Product :	PDP TV	Bulletin No.	07-PDP_TV-U002
Model :	SPS42**/HPS42**/HPS50**	Bulletin Date	JAN.29.2007
	PL**E7/PL**P7		
Buyer :	AMERICA		
Subject : Service Guide for PDP Buzzing Noise

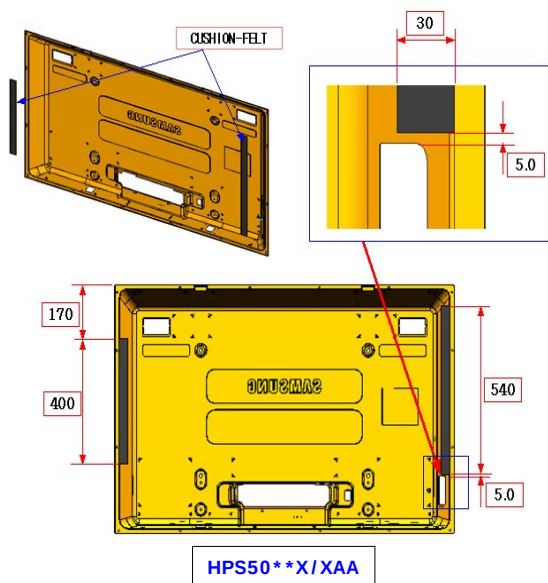
First, need to check what is making a buzzing noise

- > If noise is coming from the vibration of back cabinet, need to attach a spacer felts
- > If noise source is X, Y main board of PDP module, need to attach a damping sheet.
- > If noise source is SMPS, need to change a SMPS board

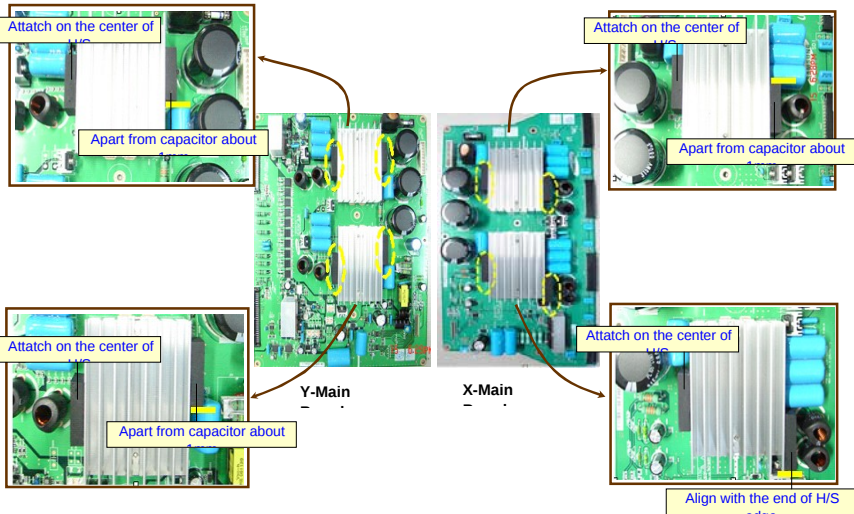
4. Attach 8 damping sheets on X-Main and Y-Main board as the below picture.
